RUSH MH 2

Service note.

Keyboard and DMX do not work.

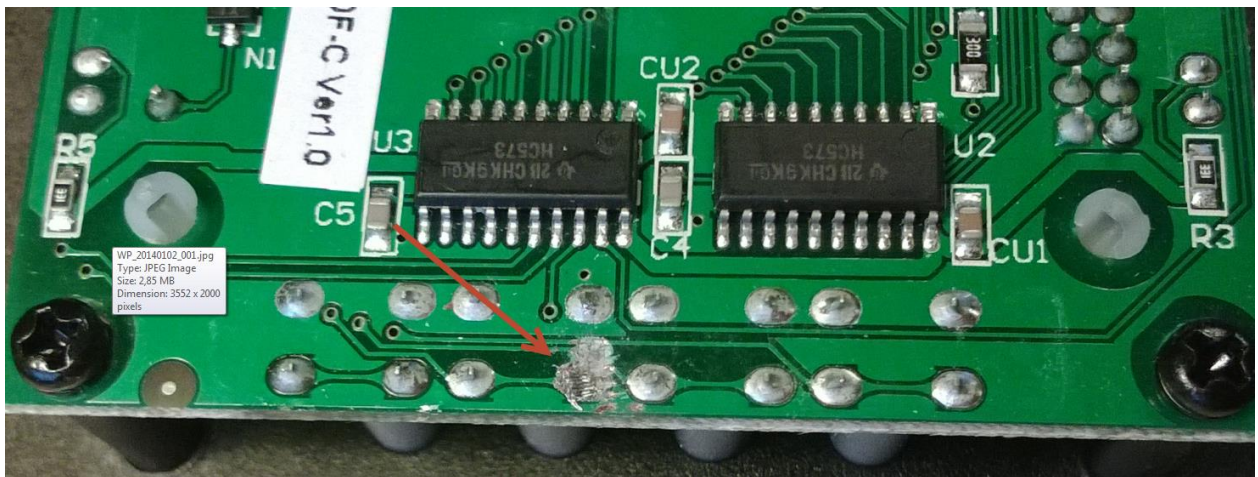
We have seen several cases where the screws for the bracket or unoriginal screws have been mounted without the washer and bracket on the MH 2.

Without the washer and bracket the screws can touch the display PCB and cause a shortcut leading to missing DMX control and no function of the buttons on the MH 2.

Only use the original screws and do not mount them without the washer and bracket.

1. Remove the screws
2. Open the fixture and swap the defect PCB with a new one (part nr: 50480571)
3. Go into the menu and do a reset
4. Then the MH 2 is ready
